Re: Petition No. 1426 - East Windsor Solar One, LLC Petition for a Declaratory Ruling, pursuant to Connecticut General Statutes §4-176 and §16-50k, for the proposed construction, maintenance and operation of a 4.9-megawatt AC solar photovoltaic electric generating facility located west of the Ellington town boundary at 341 East Road, East Windsor, and associated electrical interconnection.

Petition No. 1426

EAST WINDSOR SOLAR ONE, LLC'S RESPONSES TO THE CONNECTICUT SITING COUNCIL'S (SET ONE) OCTOBER 2, 2020 INTERROGATORIES

Figure 1: Greenhouse Gas Emissions over 20-years for Natural Gas Scenario vs. Solar Scenario per 178,607 MWh

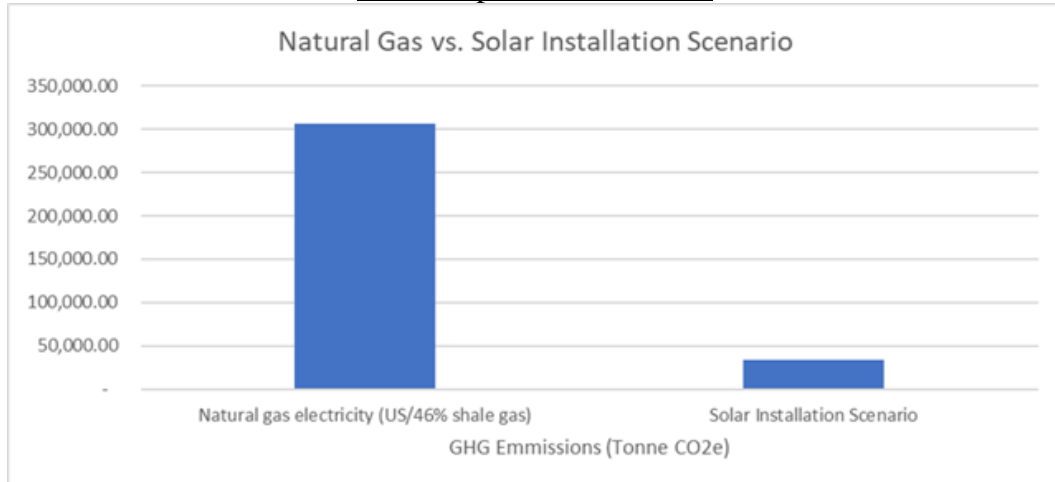
31. The Greenhouse Gas (GHG) Assessment in Appendix M of Council Petition No. 1352 compared the life cycle GHG emissions from a solar project to a scenario where the solar project is avoided and an equivalent amount of natural gas-fired electric generation operated for the estimated life of the solar facility. For the proposed project, how would the net GHG emissions (or reduction) over the life of the solar facility and carbon debt payback be affected under this natural gas-fired generation versus proposed solar generation scenario.

Using the methods and general assumptions provided in Appendix M of Council Petition No. 1352 as a foundation, and applying those principles proportionally to the subject project (Petition No. 1426), East Windsor Solar One estimates that there would be an 89 percent (%) reduction in GHG emissions by pursuing solar instead of natural gas.

More specifically, over 20 years, the Petitioner estimates that the Project will generate approximately 178,607 MWh of electricity, while emitting approximately 33,386 tons of

CO₂e. By contrast, for a natural gas generator to achieve the equivalent MWh production over 20 years, it would emit an estimated 305,791 tons of CO₂e. Please see Figure 1 below.
